CITY OF SPOKANE PARK BOARD
RIVERFRONT PARK COMMITTEE

CITY OF SPOKANE
PARKS AND RECREATION DEPARTMENT
CHANGE ORDER NO. 06

PROJECT TITLE: North Bank Playground

PROJECT NUMBER: 5188-19

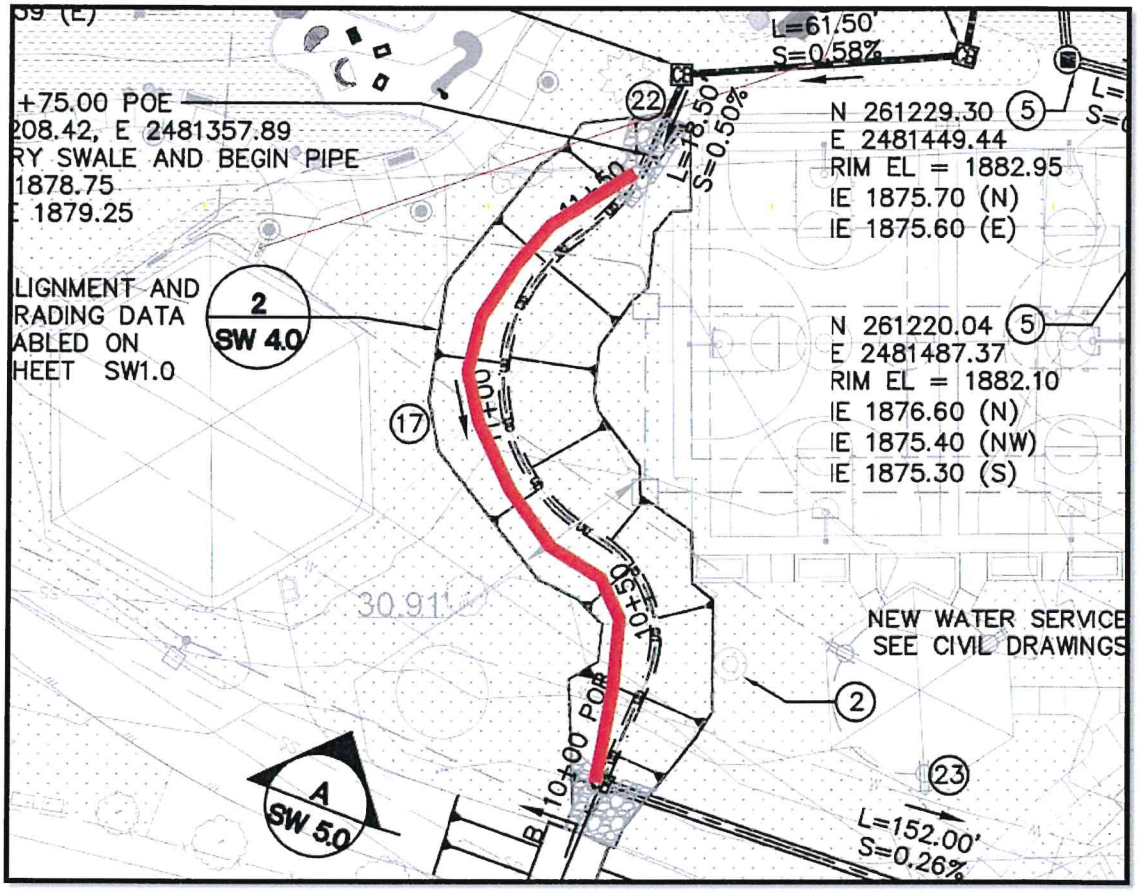
1. Concern is excavation of new catch basin near large pine tree could cause damage to the root system. (Action) Move Catch basin eastward, away from the tree rootzone to avoid root damage to the tree.

2. Concern slopes from 100 year storm drain swale could impact tree roots or basketball court and some areas seem steep or excessively deep. (Action) field adjust slopes to accommodate obstacle. Keep slope bank at 4 :1 max.

3. Concern is a nice Elm tree appears to be located in direct conflict with 24" storm line. (Action) remove tree or re-locate storm line as shown below.

1. Provide cost proposal to relocate Catch Basin east beyond tree dripline.

2. Move the swale to the west slightly as required to soften the grading between the gazebo and basketball courts. This would need to be a field fit. Softening the swale slops is intended to help with maintenance and provide increased program space. By utilizing all the space between the gazebo and basketball courts, the grades should be cut from about a 6:1 to nearly 12:1 if the grading is fairly flat.
